REMARKS

Responsive to the Office Action mailed August 5, 2005, Applicant has studied the Examiner's comments and the cited art. Claims 1, 3-16 and 21-24 are pending prior to entry of this Amendment. Following entry of this Amendment, claims 1, 3-16 and 21-24 are pending. In view of the following remarks, Applicants respectfully submit that the application is in condition for allowance.

Fig. 2A

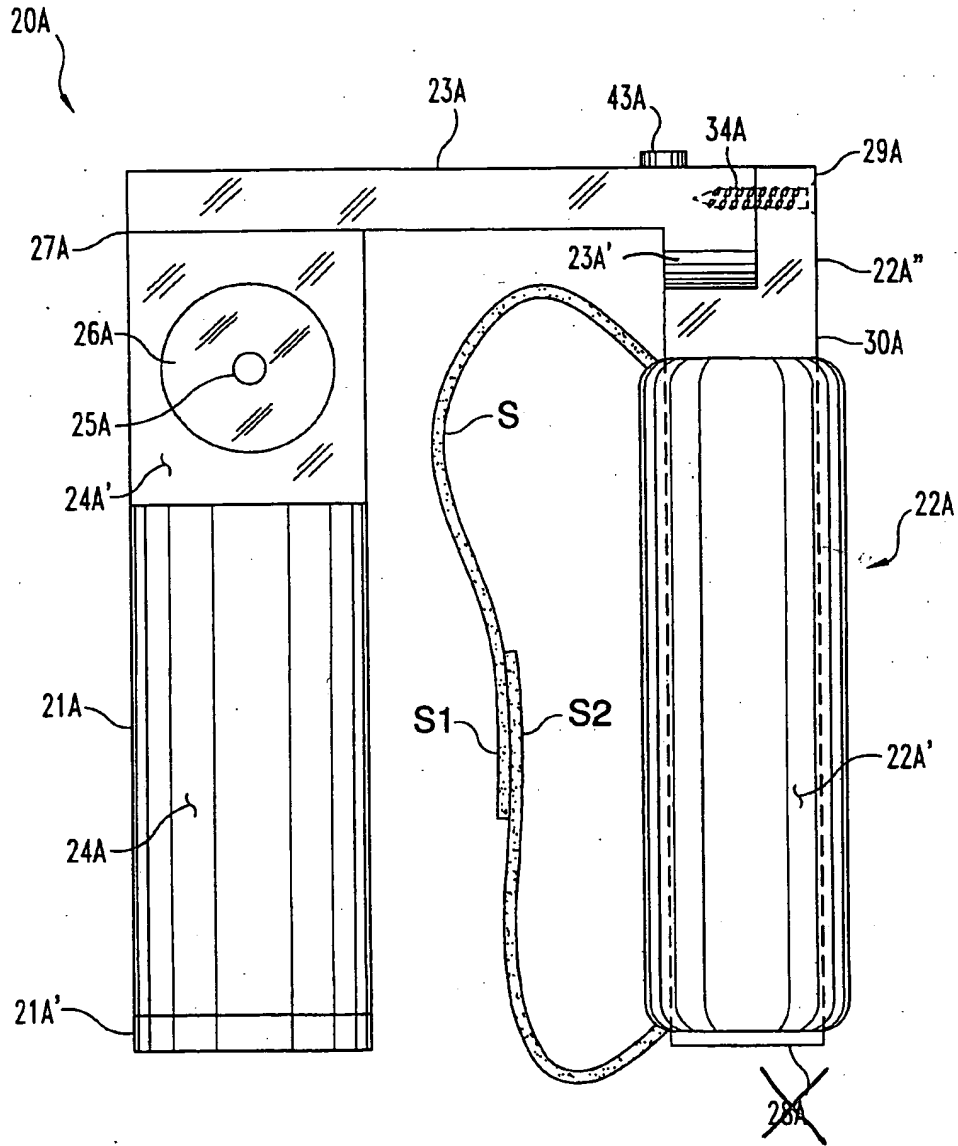
The Examiner indicates that the drawings are objected to as failing to comply with 37 CFR 1.84(p)(5) because they include the following reference characters not mentioned in the description: 28A in Fig. 2B; 88 in Fig. 17; and 96B in Fig. 20.

Applicant submits that there is no 28A in Fig. 2B, although there is a 28A in Fig. 2A. Applicant has amended the drawing to address this objection as discussed below.

Please amend drawing sheet 2 – Fig. 2A. Reference number 28A has been deleted. Applicant submits herewith a marked-up copy labeled as “Annotated Marked-Up Drawing Sheet 2 of 15” and a replacement sheet labeled as “Replacement Sheet 2 of 15.”
